Proposed Upgrade to Masterton Wastewater Treatment Plant

Response to Further Information Request by the Greater Wellington Regional Council

Appendix 1e: Proposed Homebush Effluent Disposal Site Beca & PDP Test Pits and Boreholes

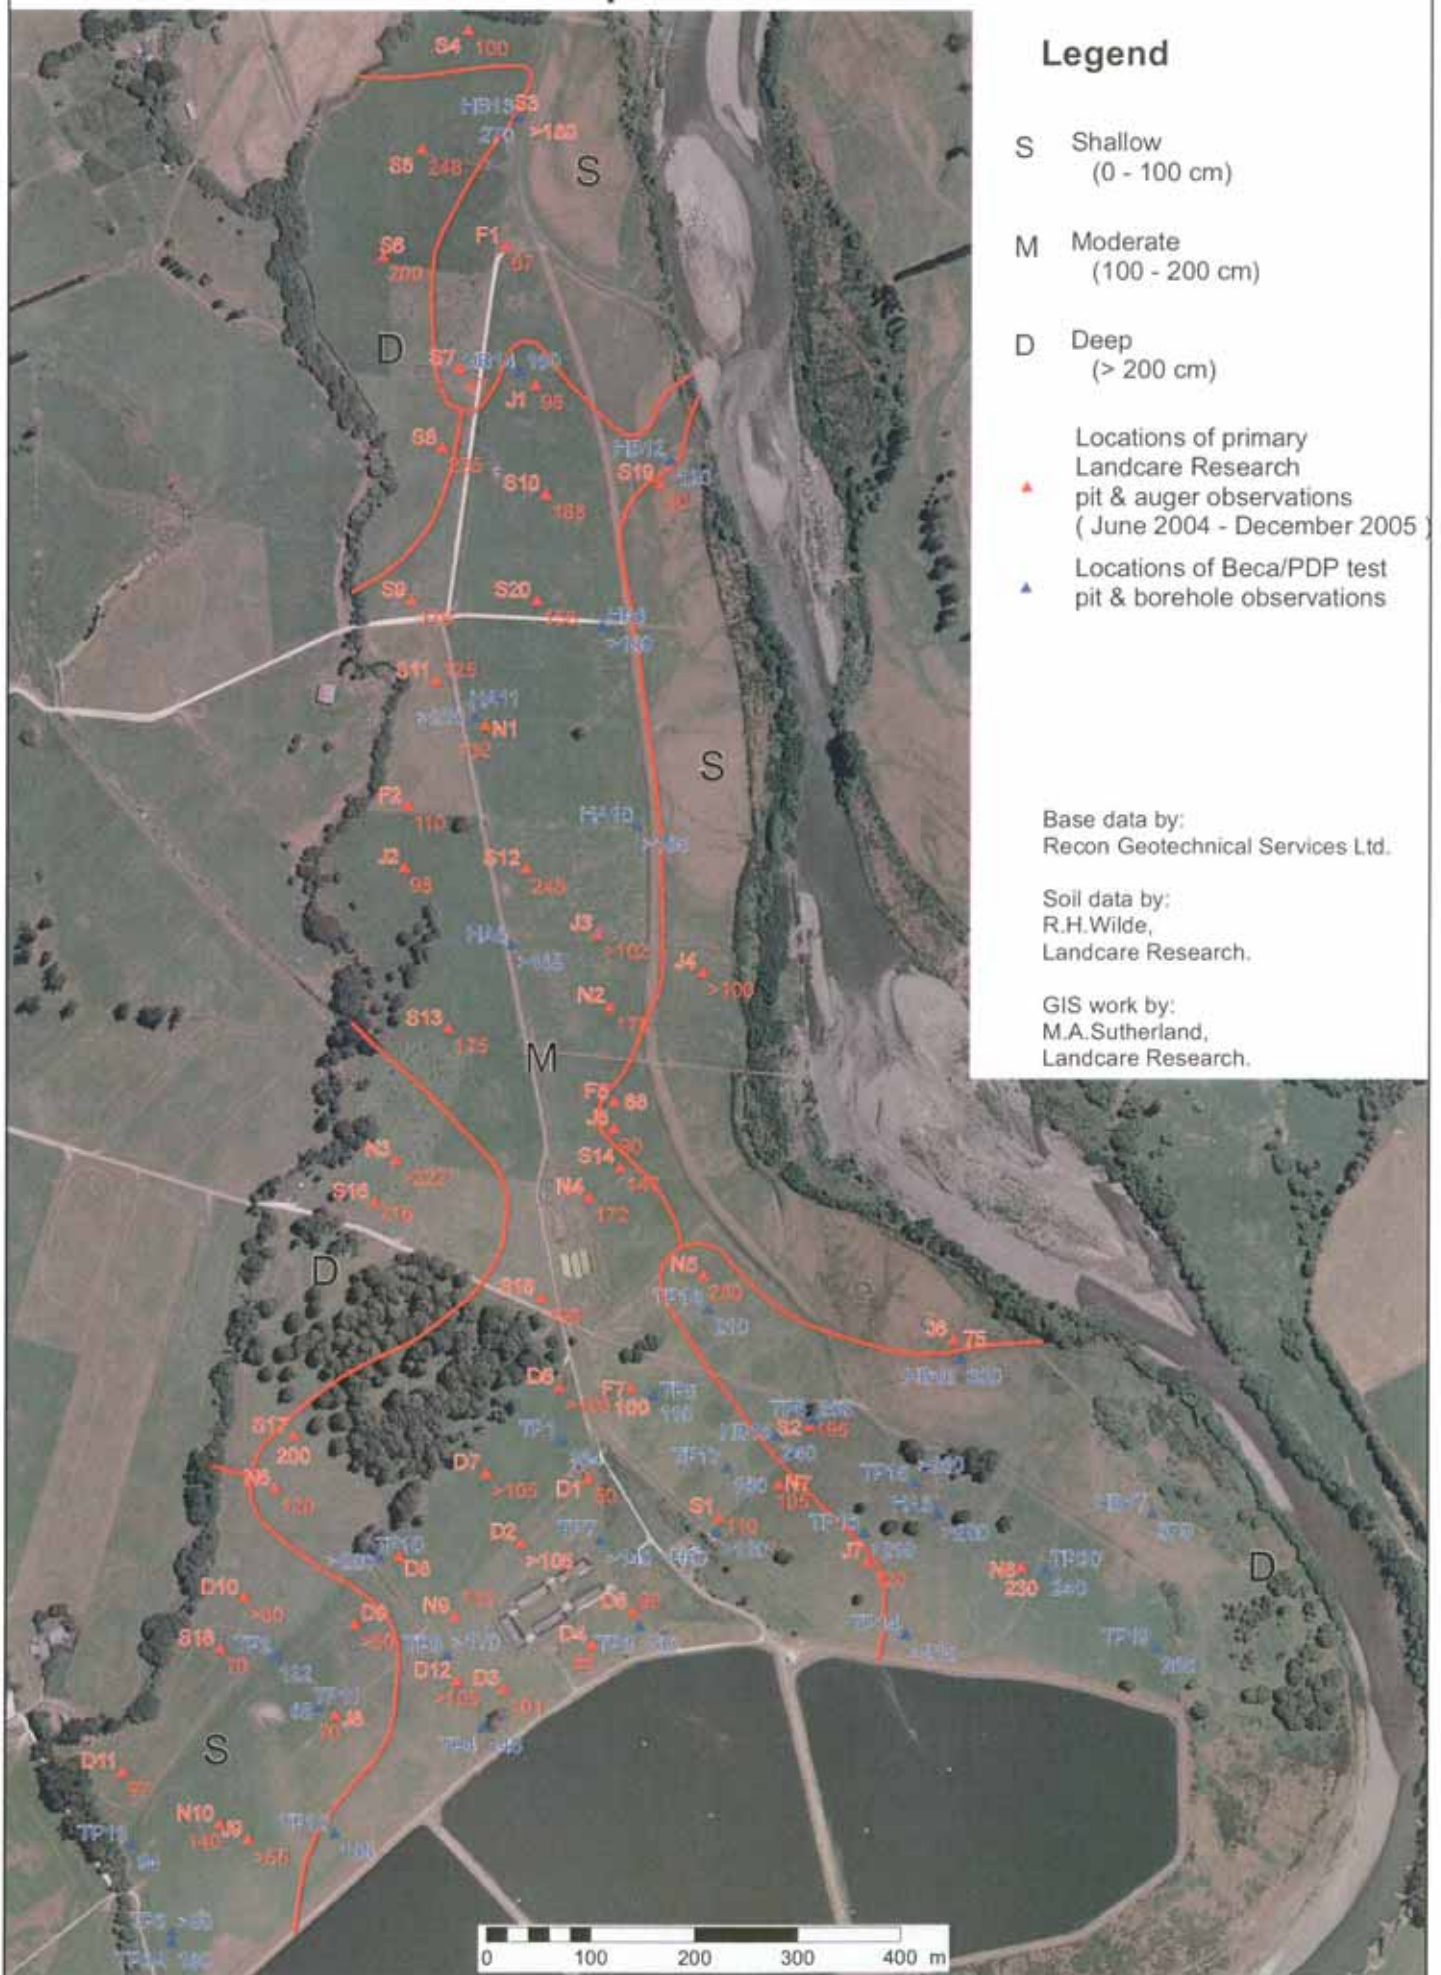
Please provide a clear map of the soils on the site.

p.51 of the AEE refers to Figure A3.1 in Appendix A3 but it is not possible to read the writing on this figure.

The text in the AEE refers to the extent of the soils investigations on the site which is shown on Figure A2.1 (not Figure A3.1 which shows the irrigation site layout). The soil types are shown on the Landcare Research plan Appendix 1a to 1e, which are included in Appendix H.

▶ **Appendix I**
**Plan Showing Proposed Groundwater
Monitoring Bores**

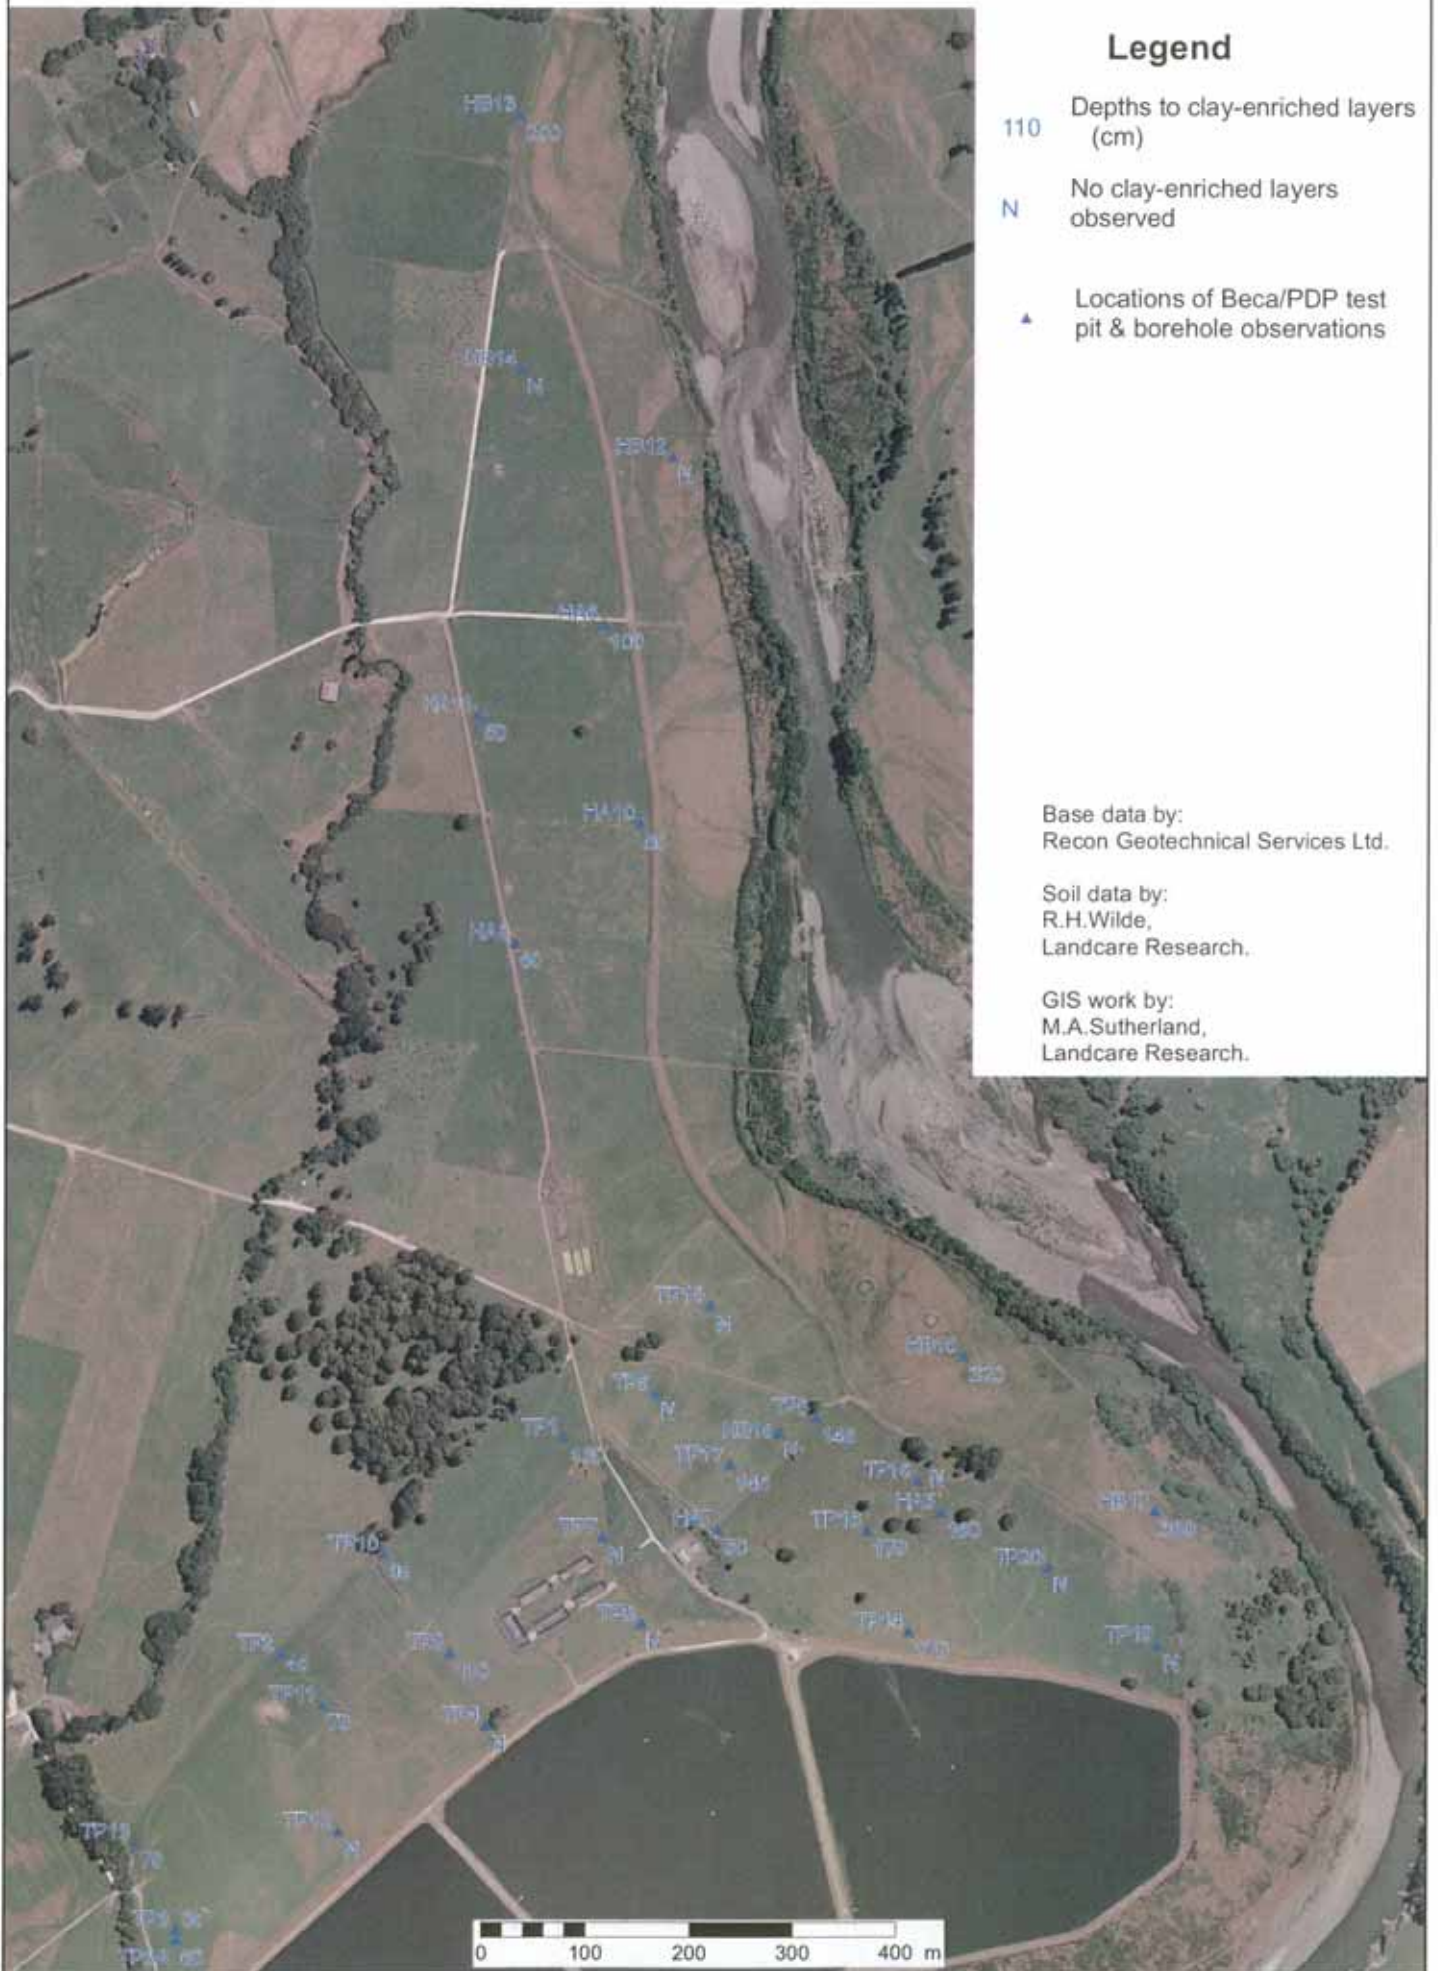
Please provide a clearer link between the Table 49 in the AEE and Figure A2.1 in Appendix 2 regarding the position of proposed monitoring bores.

A plan showing only the proposed groundwater monitoring bores is included in Appendix I.
